Art House Building Design

Statement of Modification – S4.55(1A)
R.A.N. Ski Club
Lot 263, DP 812199, South Perisher Valley

DA065-10-2010

Figure 4: First Floor Plan

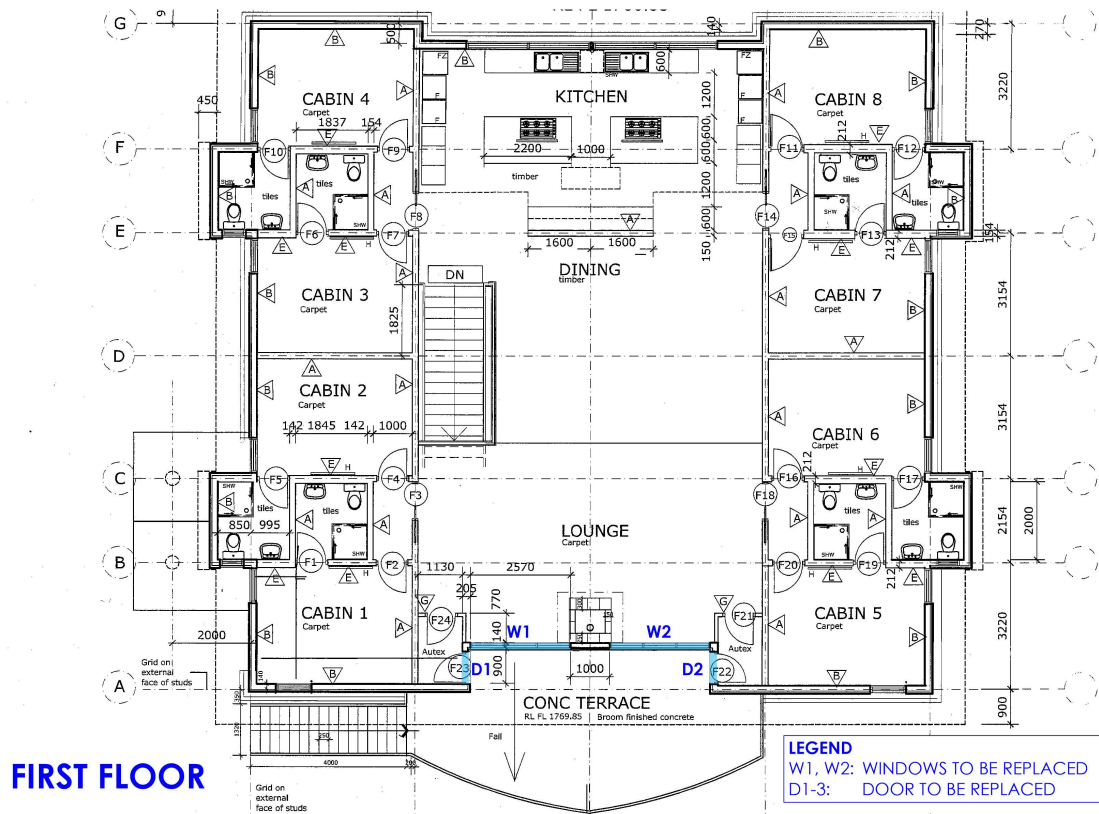
The windows are located on the first floor and face west. They are to be replaced due to leaking in strong weather from the west.

- Replacing two faulty windows to the same size and performance specification.
- Replacing three weather affected doors to match the existing dimensions.

The two PVC framed windows will be replaced with thermally broken aluminium windows of the same size and glazing performance as per the original Construction Specification as follows.

Figure 5: West Elevation

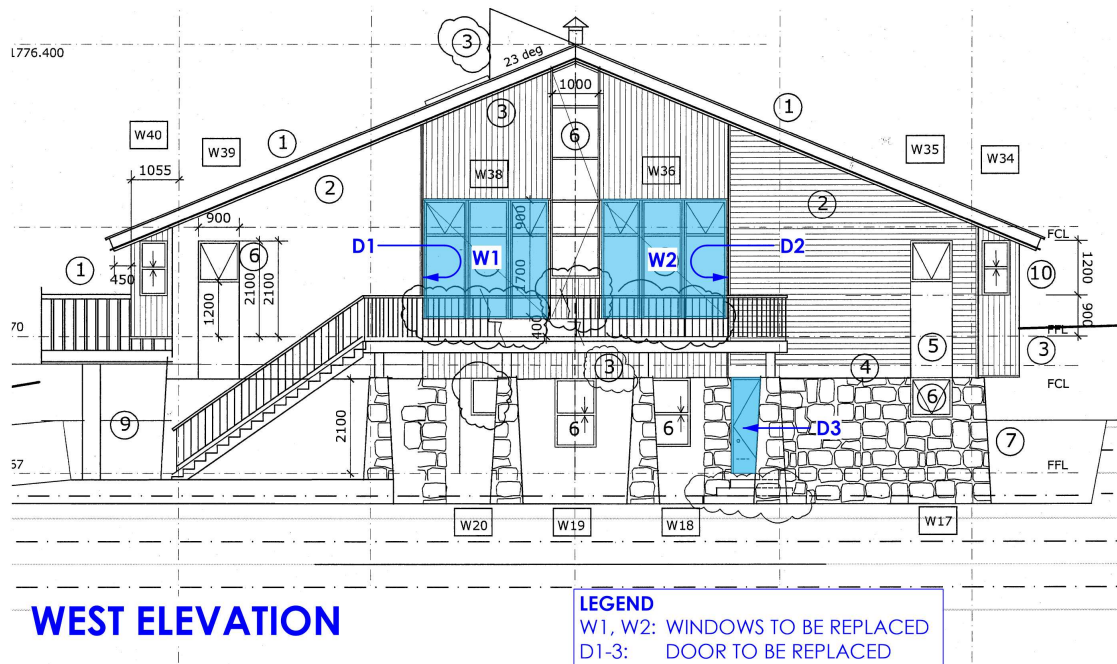
The doors to be replaced are also on the west side of the building and are deformed and rotting due to weathering.

Photo: First floor windows W1 & W2 and door D1 to be replaced.

The original DA requires BAL 19 construction to the western elevation. The replacement windows and doors will comply with BAL 19.
